IMPORTANT SAFETY RECALL

Re: Safety Recall – Smart-Steer 2.0 Self-Steer Axle with 702887 Steer Arm

SERVICE BULLETIN #SB015

Subject: SMART-STEER 2.0 Axle with 702887 Steer Arm

Replacement steer arm kit for these models is 703294-01 and contains:

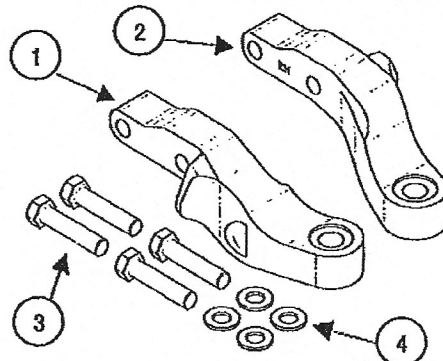
Item Number	Quantity	Part Number	Description
1	1	703293-LH	B/O steer arm LH
2	1	703293-RH	B/O steer arm RH
3	4	703100	BOLT 3/4-16UNF 3.25"lg GR8 Yellow Zinc (VMI)
4	4	701810	WASHER FLAT .75" MC2 GR8 (VMI)
Not shown	1	0150425	LOCTITE®, BLUE 242, 0.5ml

Steer Arm Welding Specifications

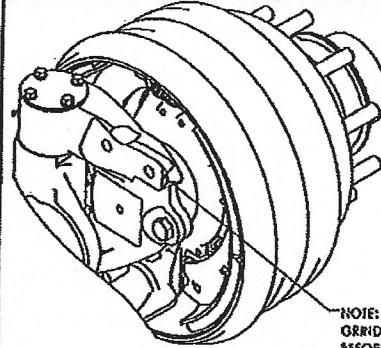
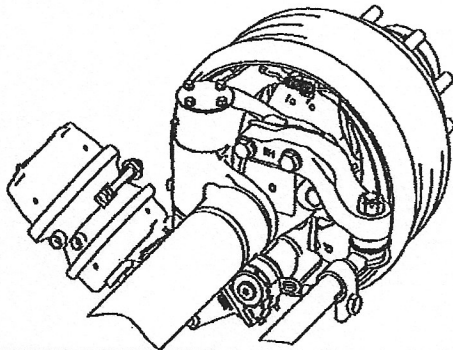
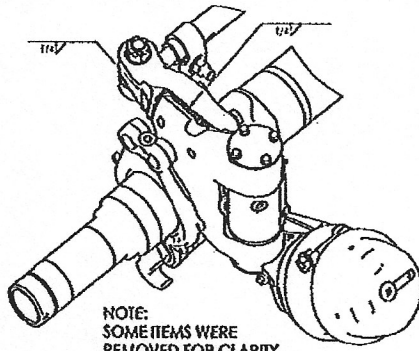
1. Remove the existing steer arms and mounting hardware.
2. Clean mounting surface and surrounding surfaces to prepare for mounting of the new bolt-on steer arm and additional welds.
3. Grind a 3/16" chamfer along the mounting face edge (see page three for location & detail).
4. Mount new design steer arms (Part # 703293-LH/RH) with supplied hardware and torque to 400 ft-lbs.
5. Add welds as shown on page three of this bulletin.

NOTE:
GRIND 3/16" X 45° CHAMFER
BEFORE INSTALLING STEER ARM
